GUSSIE NELL DAVIS
RANGERETTE RESIDENCE
KILGORE COLLEGE

Addendum No. 1
to the Proposal Documents for
GUSSIE NELL DAVIS RANGERETTE RESIDENCE
KILGORE COLLEGE
Kilgore, Texas

Addendum No. 2
to the Proposal Documents for
GUSSIE NELL DAVIS RANGERETTE RESIDENCE
KILGORE COLLEGE
Kilgore, Texas

Addendum No. 3
to the Proposal Documents for
GUSSIE NELL DAVIS RANGERETTE RESIDENCE
KILGORE COLLEGE
Kilgore, Texas

LIGHTING
FLOOR PLAN- FIRST FLOOR

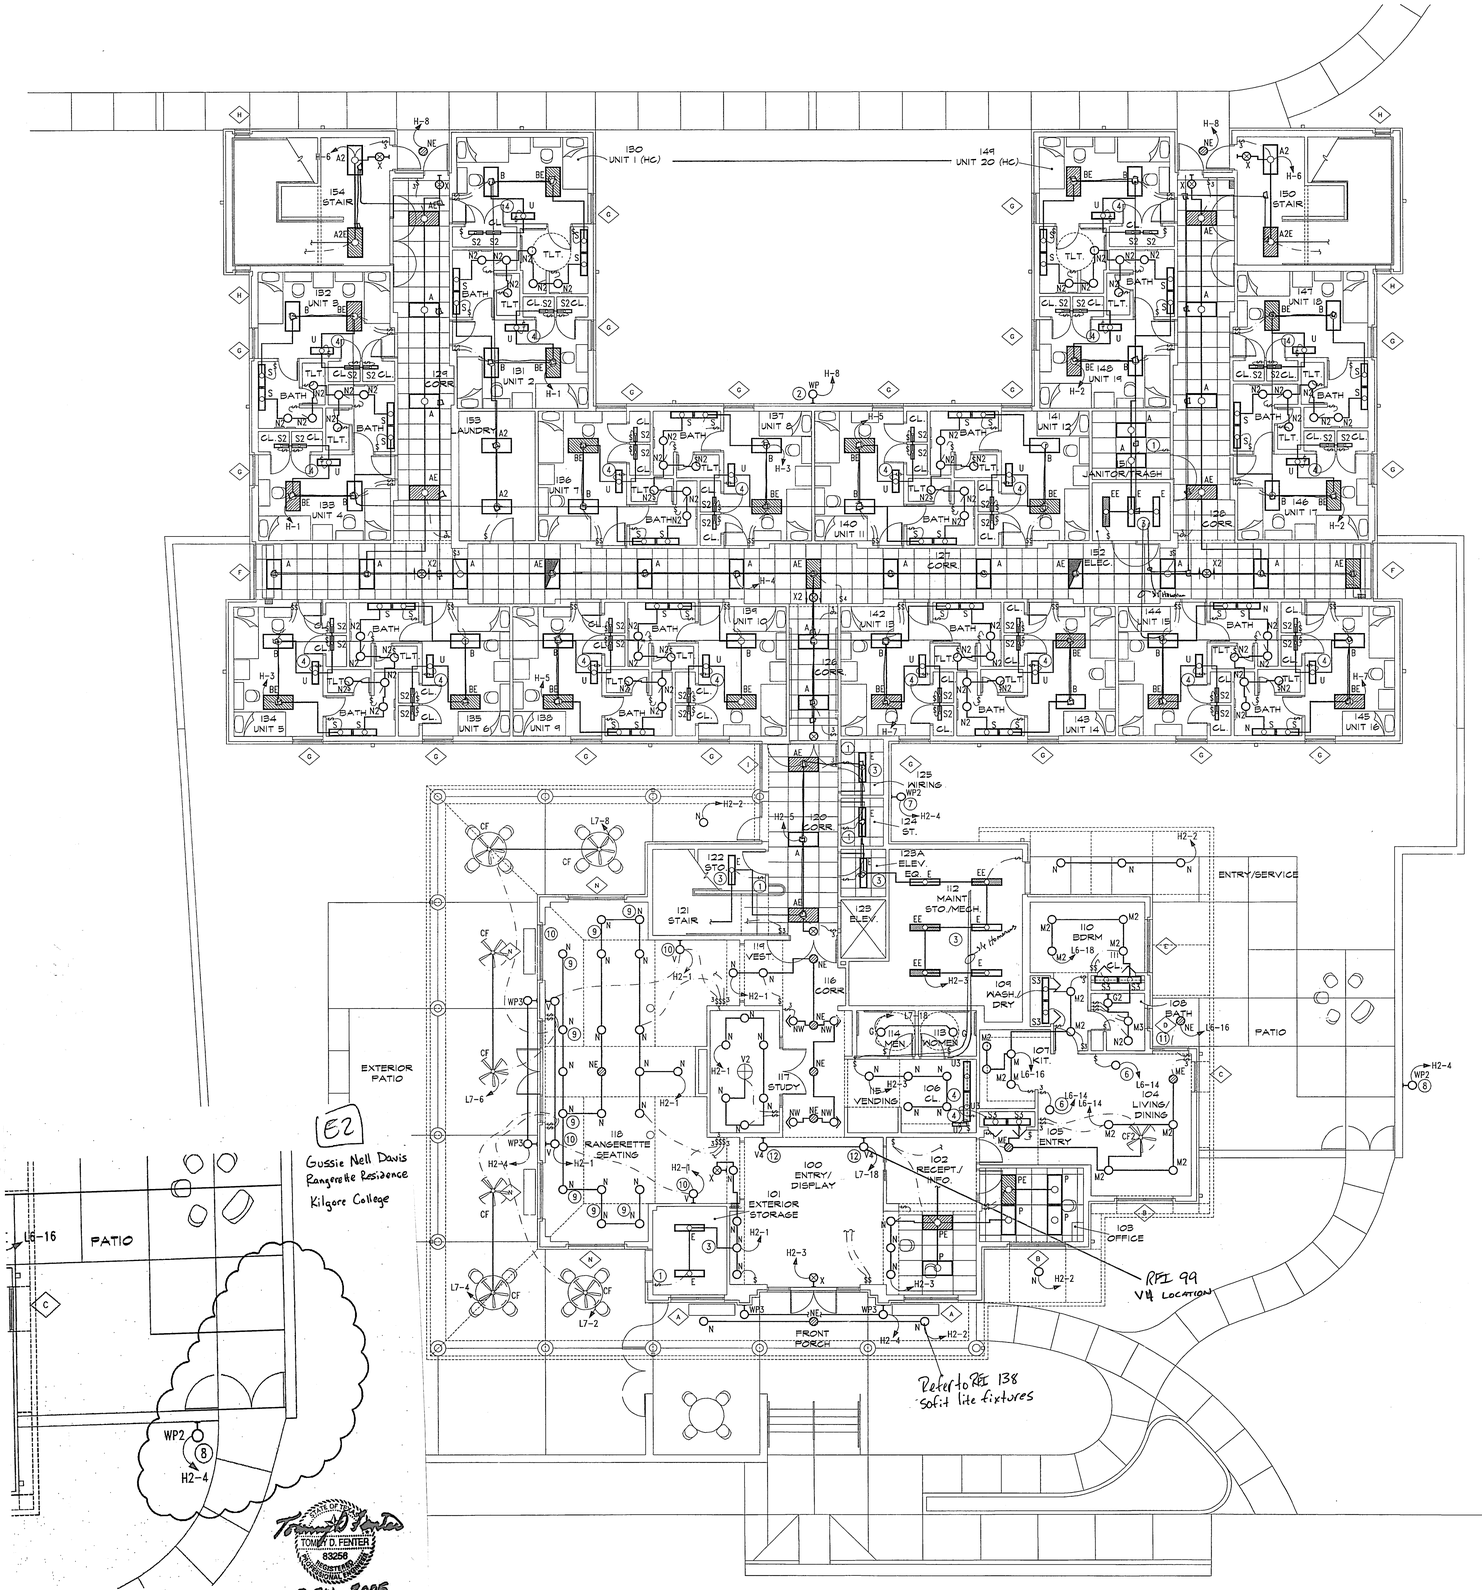
Sheet EL 2.0
A. Refer to Floor Plan.
1. For changes to exterior lighting, see Attachment E2.

Sheet EL 2.0
A. Refer to Floor Plan.
1. On west wall of Entry 100, place 4 recessed can lights in lieu of 3 recessed can lights as previously indicated.

LIGHTING
FLOOR PLAN- SECOND FLOOR

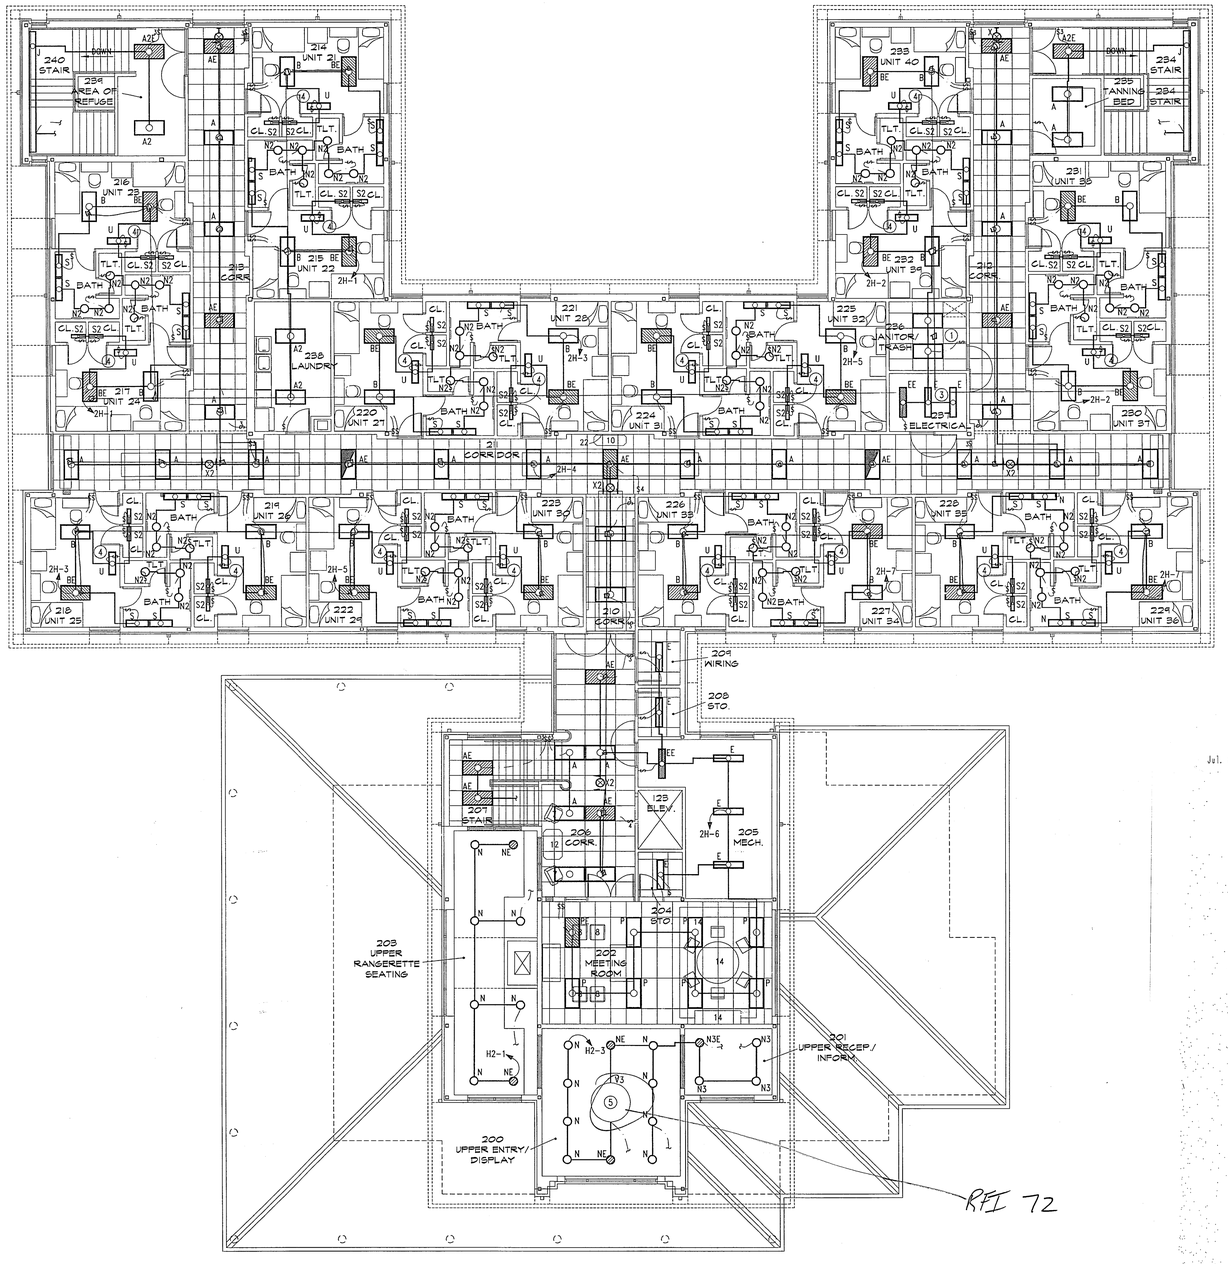
Sheet EL2.1
A. Refer to Floor Plan.
1. For changes to lighting, see Attachment E3.

Sheet T 2.1

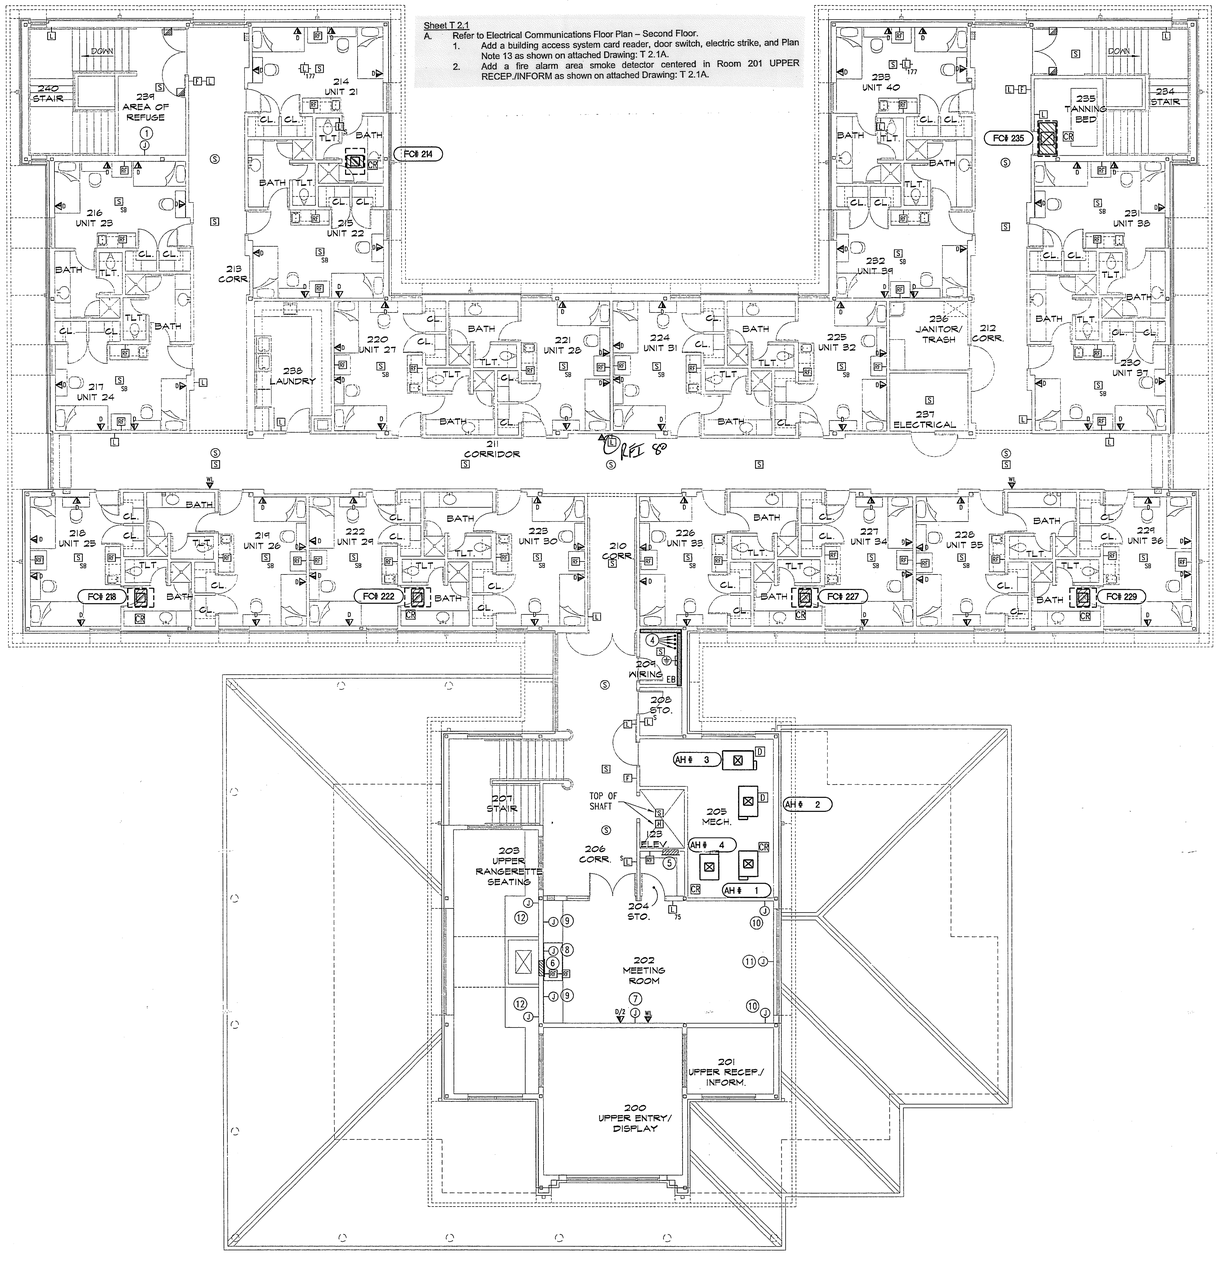
A. Refer to Electrical Communications Floor Plan – Second Floor.
   1. Add a building access system card reader, door switch, electric strike, and Plan Note 13 as shown on attached Drawing: T 2.1A.
   2. Add a fire alarm area smoke detector centered in Room 201 UPPER RECEP./INFORM as shown on attached Drawing: T 2.1A.

5 PLUMBING RISERS

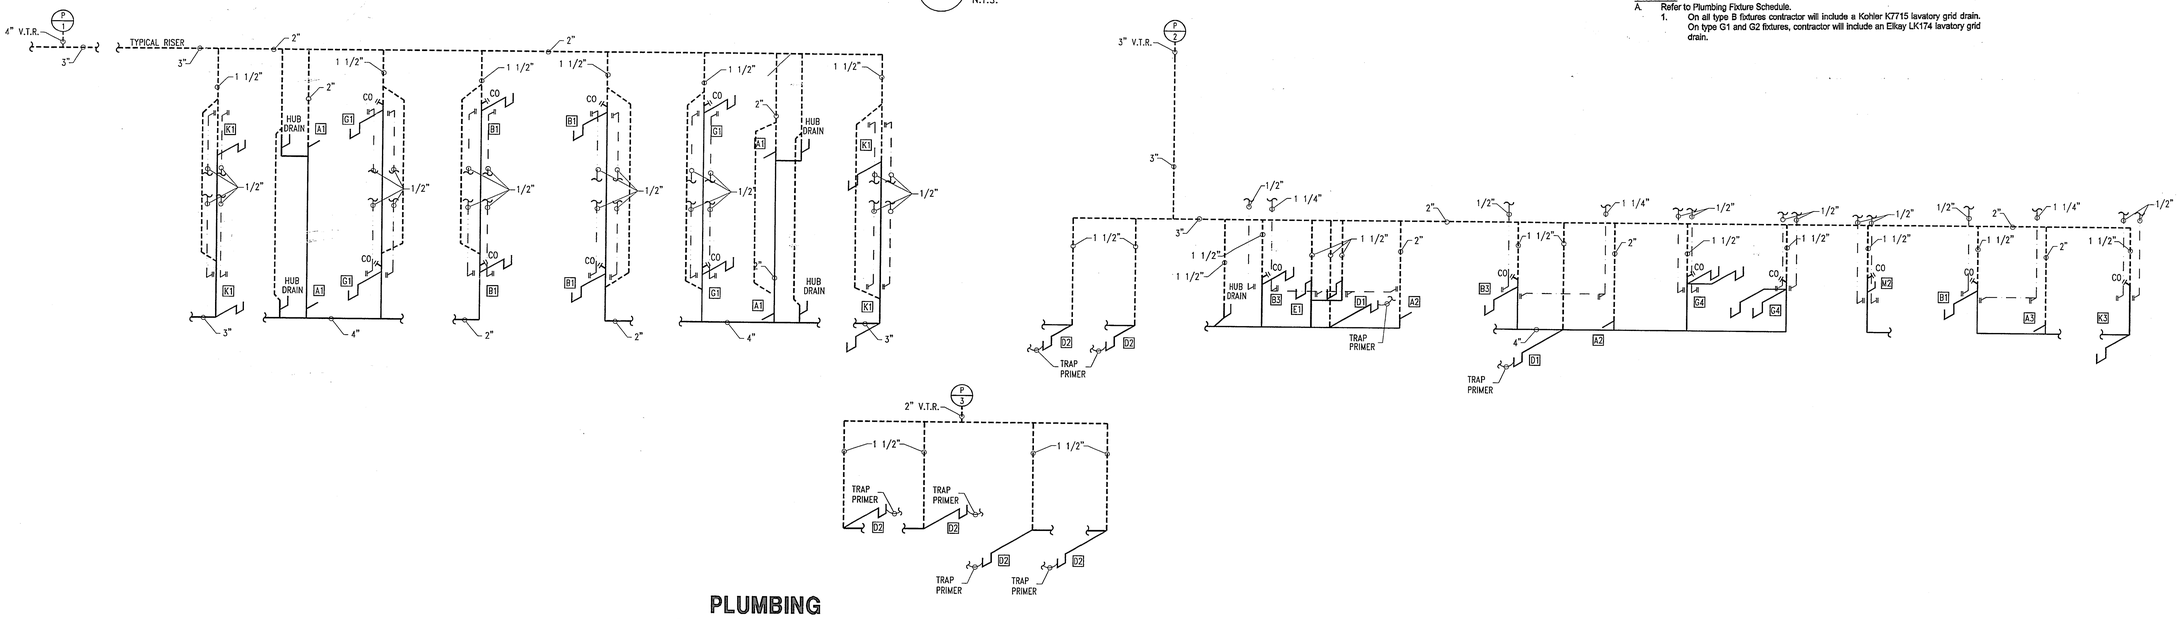
Sheet P 6.0
A. Refer to Plumbing Fixture Schedule.
1. On all type B fixtures contractor will include a Kohler K7715 lavatory grid drain. On type G1 and G2 fixtures, contractor will include an Elkay LK174 lavatory grid drain.
